SUBJECT: REQUESTS LICENSE AMEND TO ALLOW SMALL POSITIVE MODERATOR
 TEMP COEFFICIENT DURING REACTOR STARTUP & VARIOUS
 ADMINISTRATIVE CHANGES. FORWARDS PROPOSED REVISIONS TO TECH
 SPECS, SUPPORTING ANALYSIS & \$5,200 AMEND FEE.

H. B. ROBINSON STEAM ELECTRIC PLANT, UNIT NO. 2
DOCKET NO. 50-261
LICENSE NO. DPR-23

LICENSE AMENDMENT TO ALLOW A SMALL POSITIVE
MODERATOR TEMPERATURE COEFFICIENT AND VARIOUS ADMINISTRATIVE CHANGES

Figure 3.10-2 SHUTDOWN MARGIN VS BORON CONCENTRATION

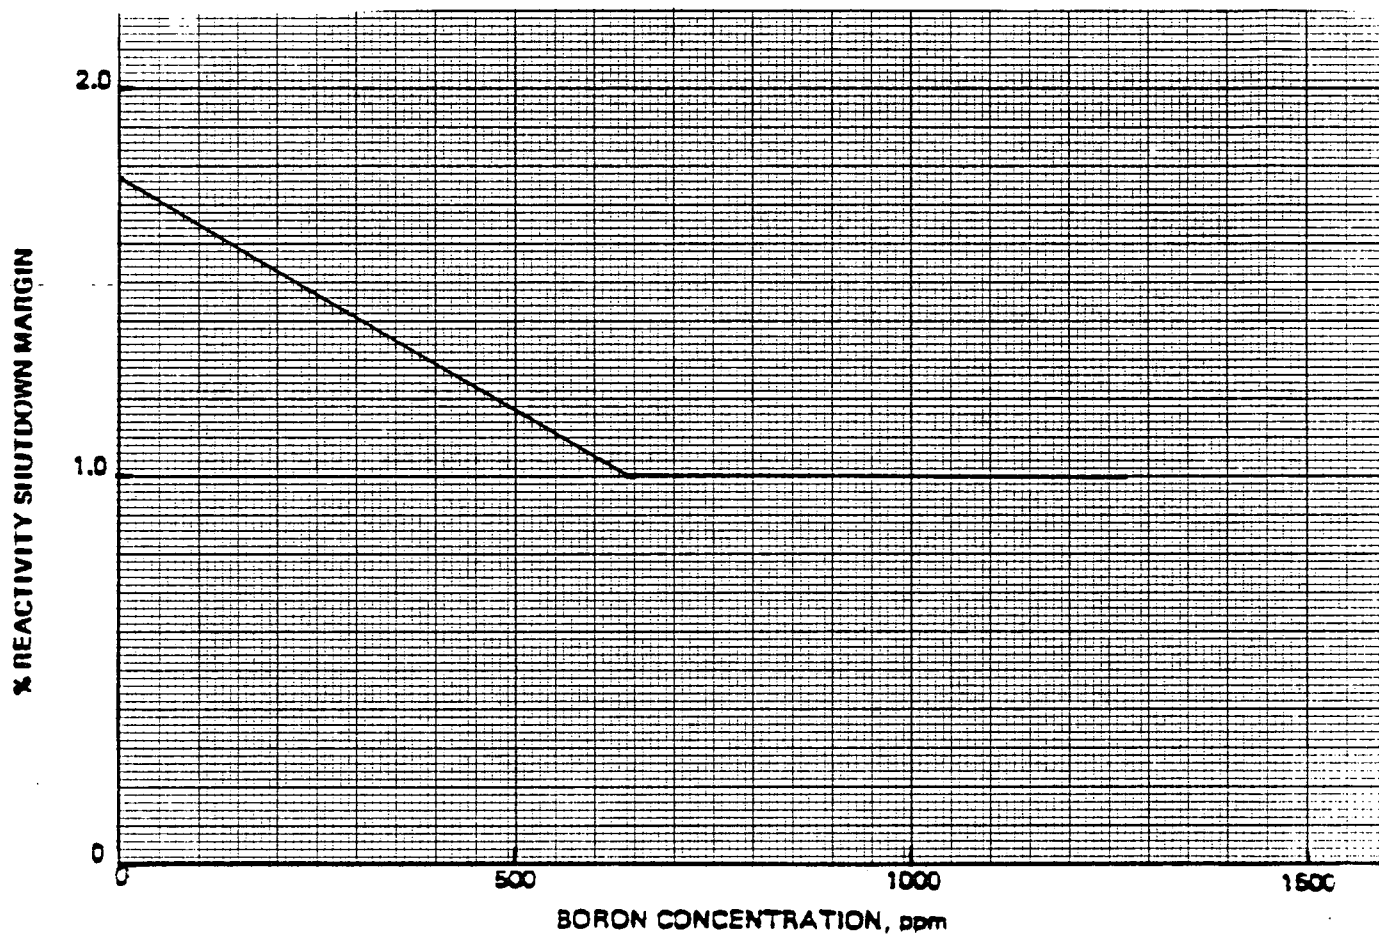
The other attached changes are administrative in nature. They delete references to early cycle requirements, correct figures or clarify wording. The change to Figure 3.10-2 changes the Zero Boron Shutdown Margin to 1.77. This is the number that was actually used in the Safety Analysis, and the graph is being changed to conform with it.

3.10.1.6 Insertion limits do not apply during physics tests or during periodic exercise of individual rods. However, the shutdown margin indicated in Figure 3.10-2 must be maintained except for the low power physics test to measure control rod worth and shutdown margin. For this test the reactor may be critical with all but one full length control rod inserted.
